**RESOLUTION AUTHORIZING CONTRACT MODIFICATION #02
FOR THE PURAC PHASE III PROJECT**

Subject: North Hudson Sewerage Authority
Project No. S340635-30
PURAC System Improvements Phase 3 – Physical System Improvements
Contract Modification No. P-02

No. P-02:

Cell 3 East side – return wear block hits third anchor bolt

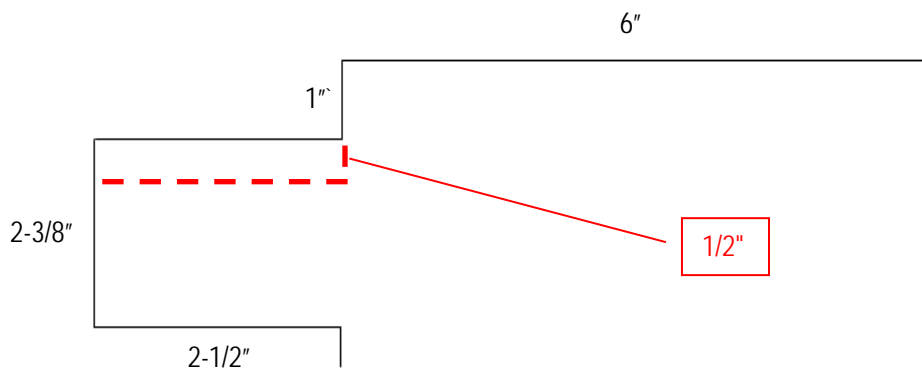
1. Remove third anchor if AWC determines that placement of remaining two 1" anchors are sufficient
2. Trim return wear block – reducing the height of the projection on the wear block by 1/2" as pictured below should avoid conflict with bolt. This would lower the overall elevation of the skimmer by the same distance when it is traveling on the upper rail. RPM would recommend modifying a single block and testing it in order to ensure the conflict is resolved.

Cell 3 East side – return wear block hits bearing bracket angle

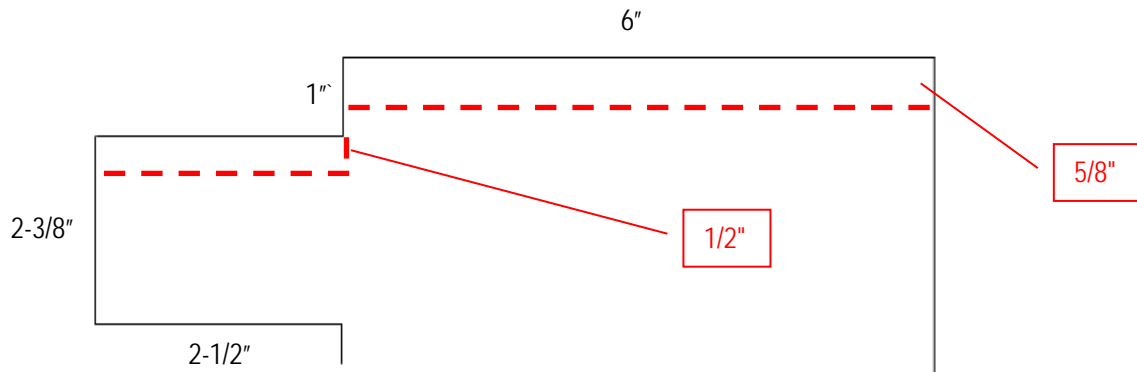
1. AWC has recommended trimming the bearing support bracket with a 1" x 1" notch on as pictured to the right. This solution does not appear to be sufficient as the block would appear to still hit the bearing housing.

Cell 3 West side – return wear block hits bearing bracket angle

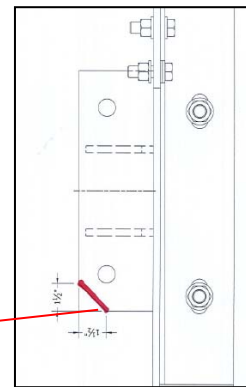
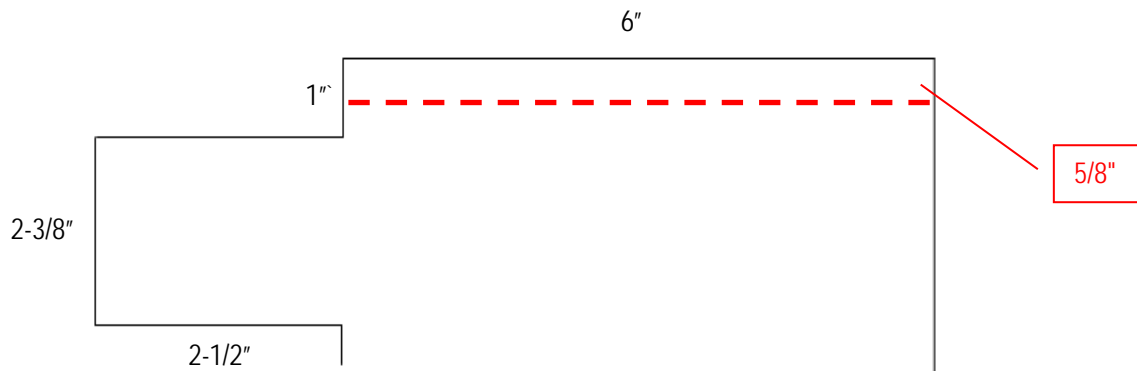
1. AWC has recommended trimming the bearing support bracket with a 1-1/2" x 1-1/2" notch on as pictured to the right. This solution does not appear to be sufficient as the block would appear to still hit the bearing housing. **Please also note that the support bracket is 13" and not 12" as was indicated on the most recent drawing.**

2. Trim return wear block – reducing the overall height of the wear block by 5/8" as pictured below should reduce conflict with the bracket. This would lower the size of the "step" used to align the skimmer as it is traveling along the top rail. This modification could also be combined with the 1/2" modification of the projection proposed above which would largely maintain that step size. RPM would recommend modifying a single block and testing it in order to ensure the conflict is resolved.

NORTH HUDSON SEWERAGE WWTP (PO. #10382) AWC Model DAF/Flo-Filter WWTP WEAR BLOCK MODIFICATION SHEET 1 OF 1	
DRAWING NO.	10382-04-06
REV	-

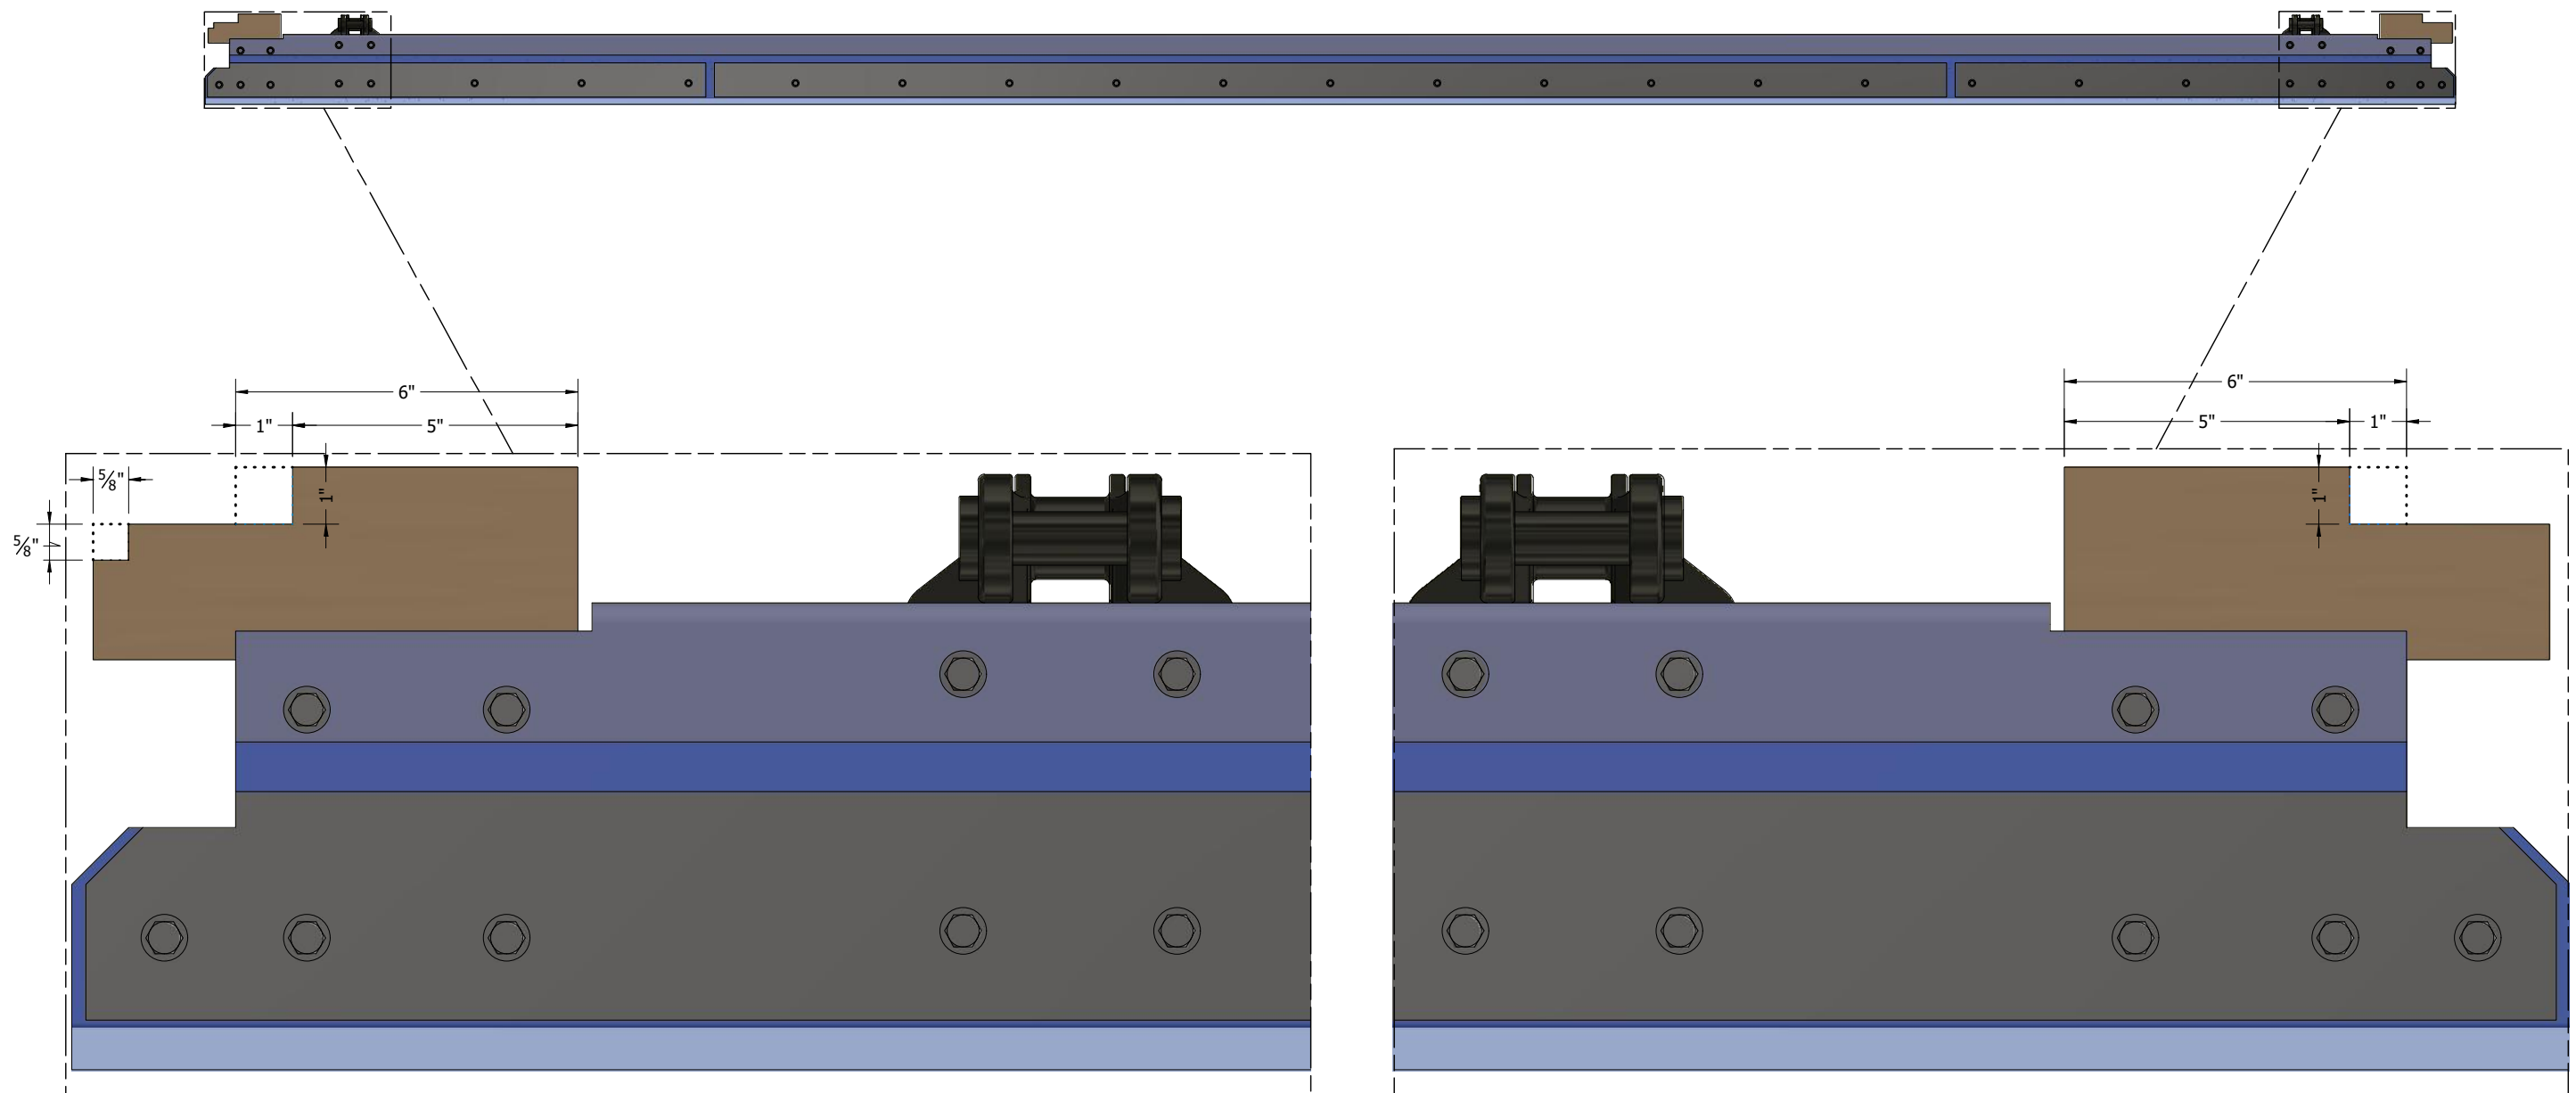
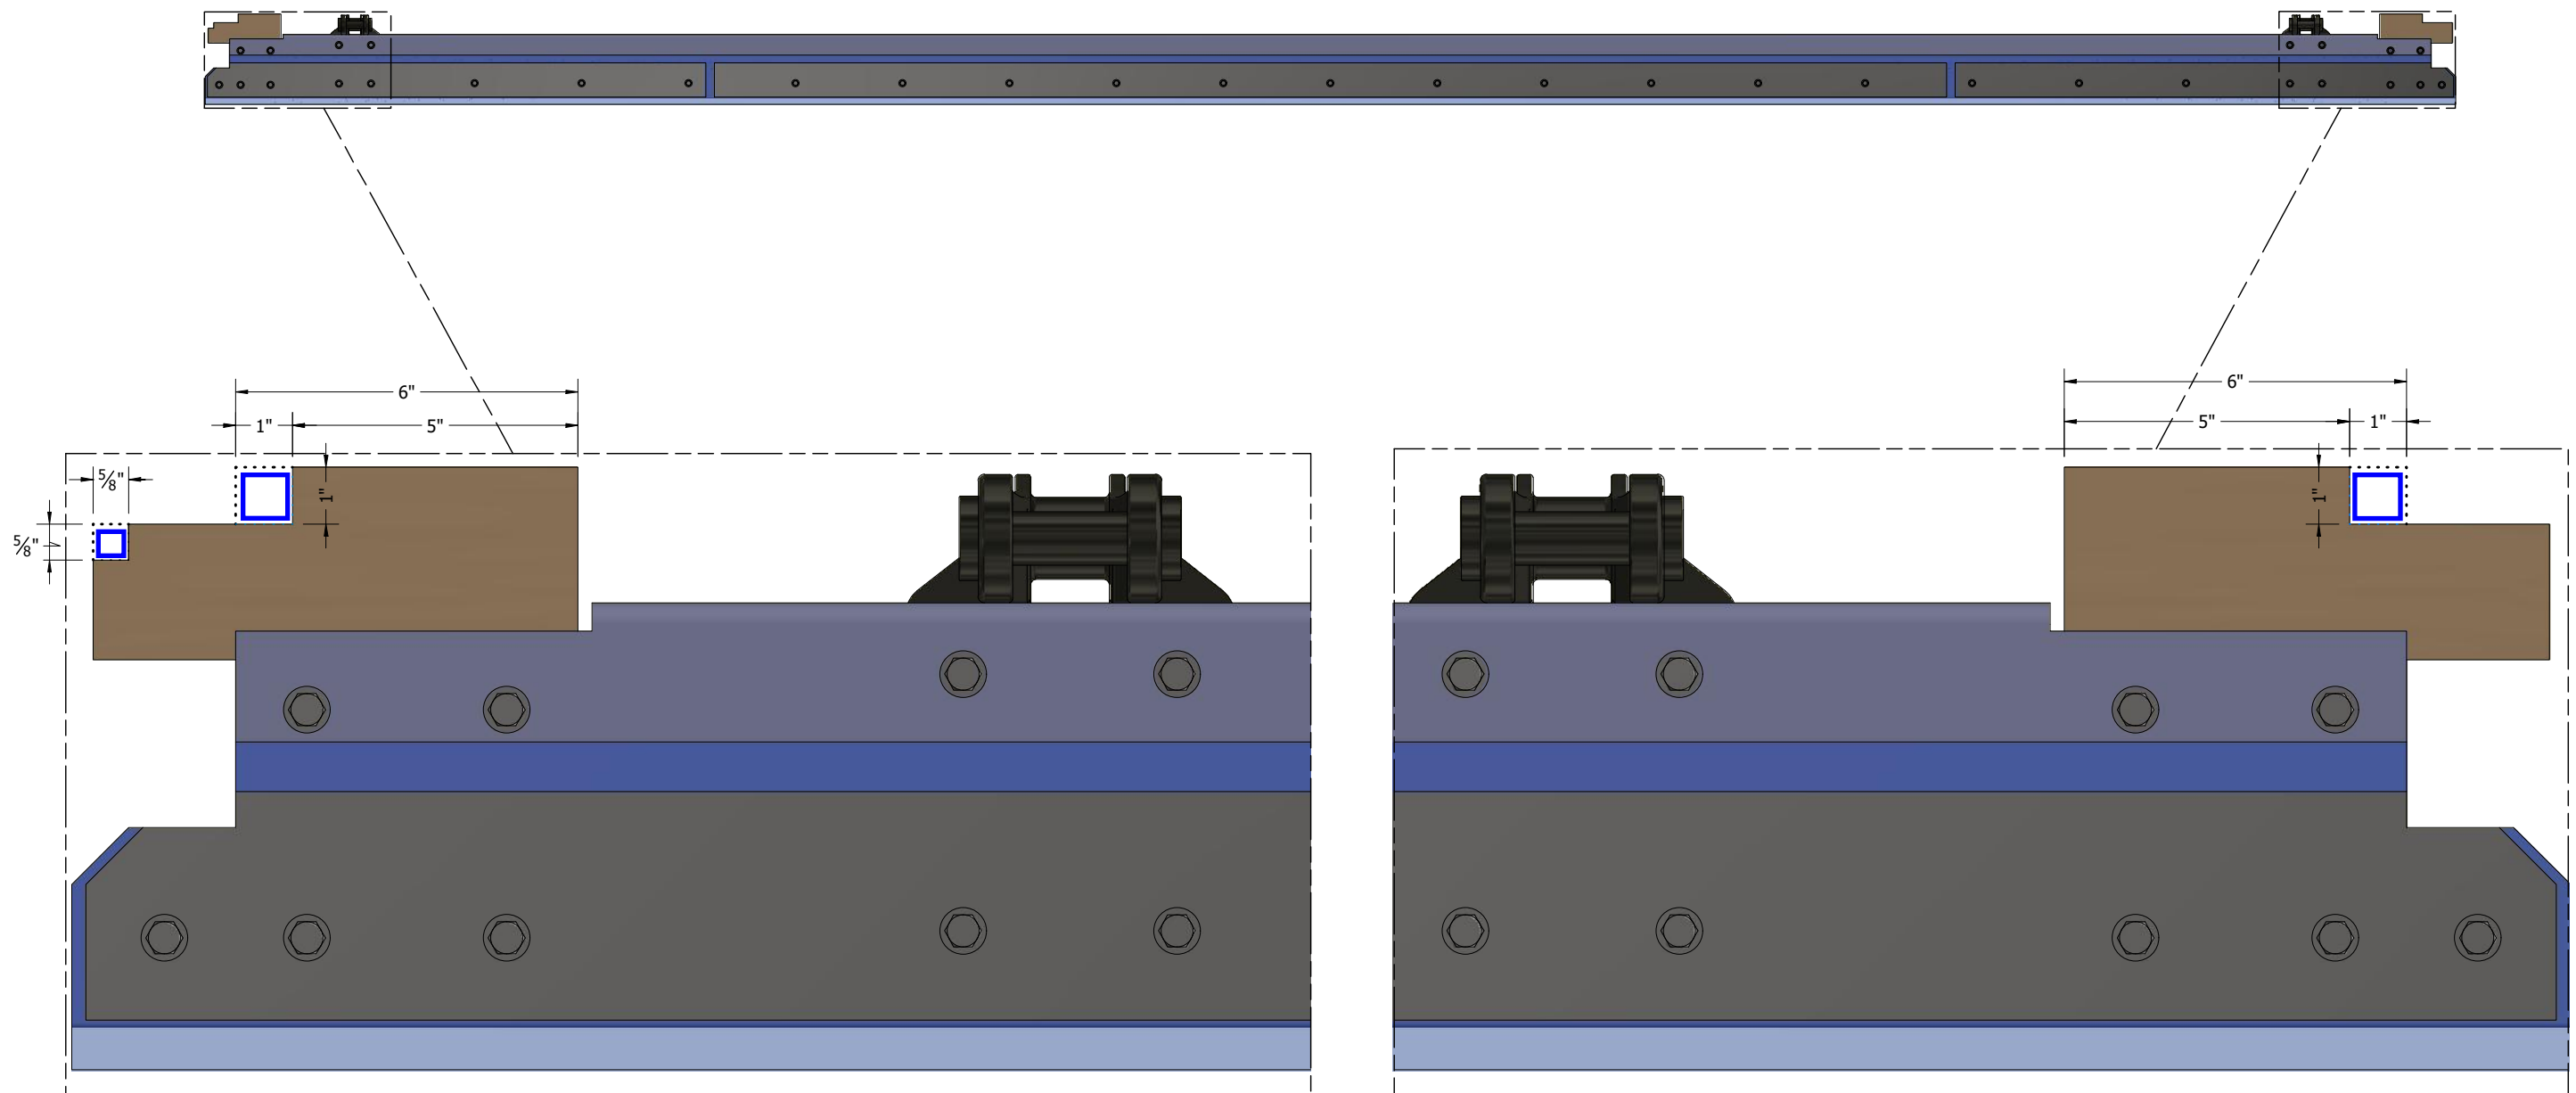
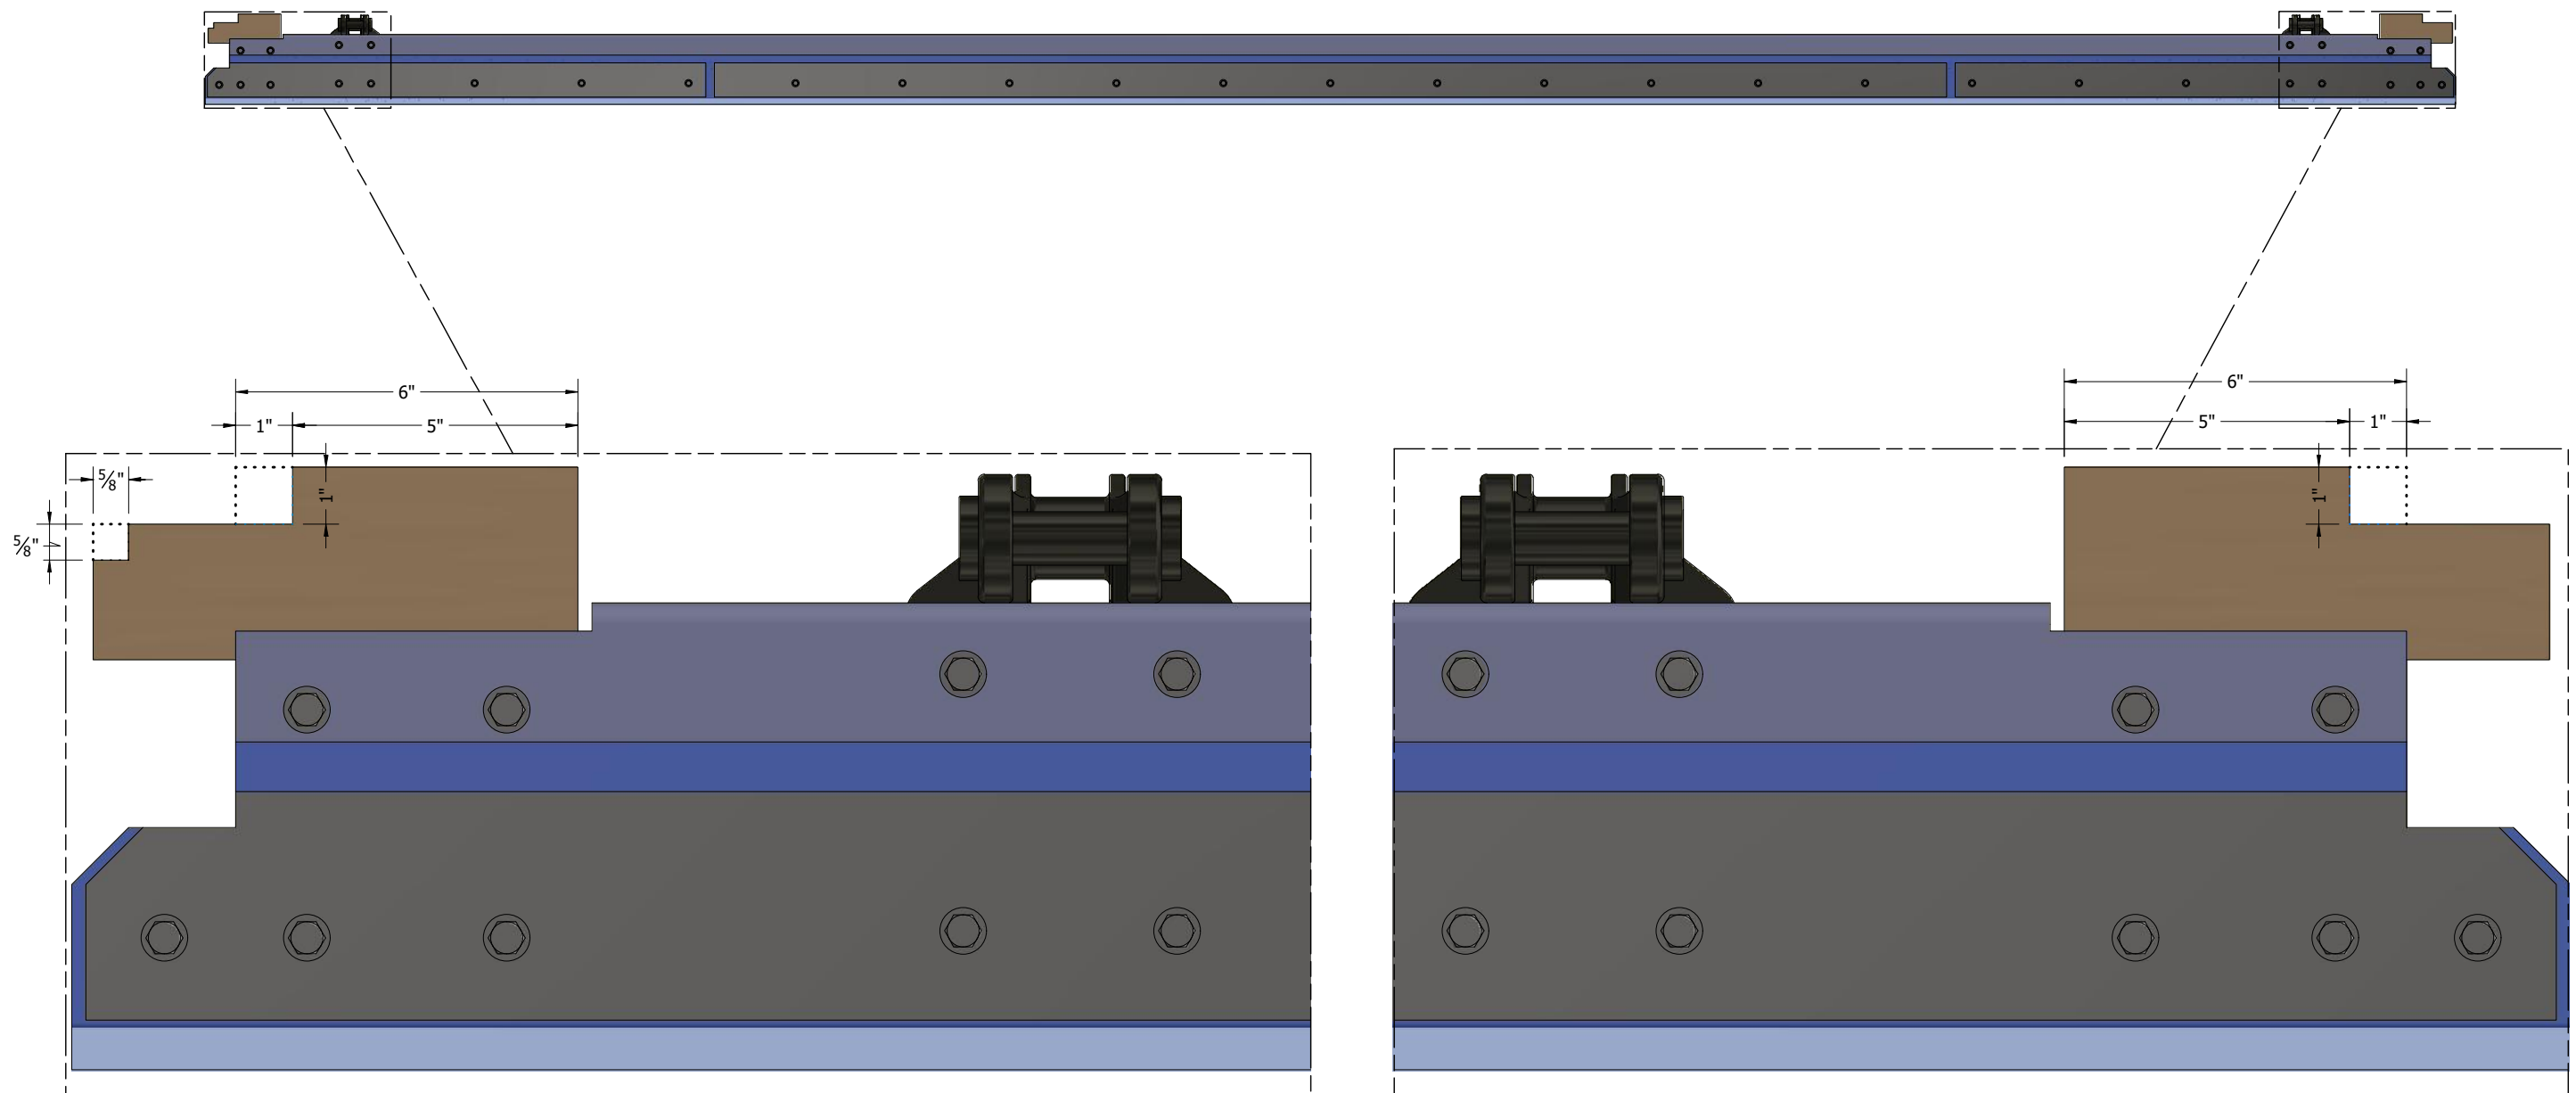
- Remove each of the 72 Flight Return Wear Blocks from all skimmer flights in Cell 3 and 4.
- Trim Blocks as recommended by AWC engineer – see attached AWC – Return Wear Block – Modification drawing.
- Reinstall newly modified blocks to 36 Skimmer Flights for future installation for Cell 3 and 4

The as-found condition of the Filter Cells post-demolition exceeded the tolerances of the skimmer equipment.

See below attached response/drawings showing new dimensions for return block. Trim just (2) blocks as shown in the drawings attached. Once Blocks are trimmed install and test the flight travel over the sprocket.
